## FLEET HOUSE \_ SCHEDULE OF PROPOSED PLANNING AMENDMENTS:

Project Fleet House

3 Admiral's Walk, Hampstead London NW3 6RS

Proposed Layout Location Plan

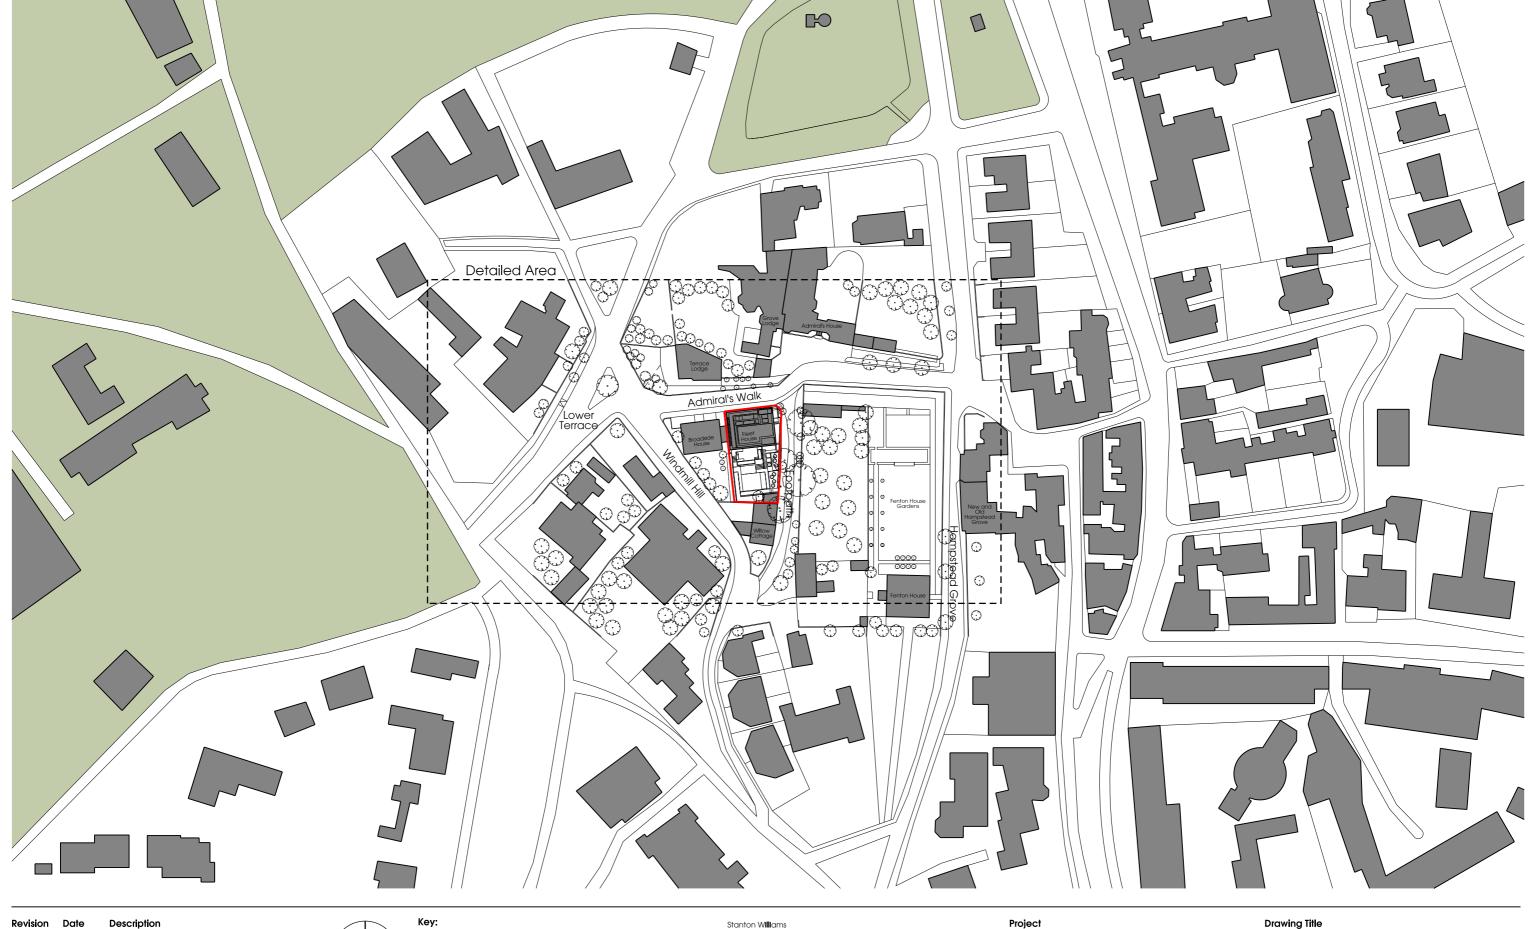
- 1. Amendments to proportions of building resulting in a reduced floorspace.
- 2. Changes to basement courtyard resulting in reduced amount of excavation.

- 3. Amendments to roof layout comprising alterations to roof lights, removal of one rooflight and provision of roof hatch and solar panels.
- 4. Changes to first floor roof including detailed design of approved metal balustrade and provision of stone surfacing on area outside master bedroom.

- 5. Changes to elevational treatment of building to simplify design including use of brick instead of stone for panel next to first floor front window, use of brick and metal instead of render for side and rear elevation panels, provision of metal vent on side elevation to provide natural ventilation to wet room, use of quarzite stone in entrance area, roof coping to be metal.

- 6. Changes to design of garden outbuilding to include sedum roof, timber cladding instead of timber louvres and slot window next to door instead of perforations.

- 7. Alterations to fenestration including readjustment to design of box window, rear and side windows. Changes to details of window reveals.
- 8. Change to position of manifold chamber for ground source heat pumps.
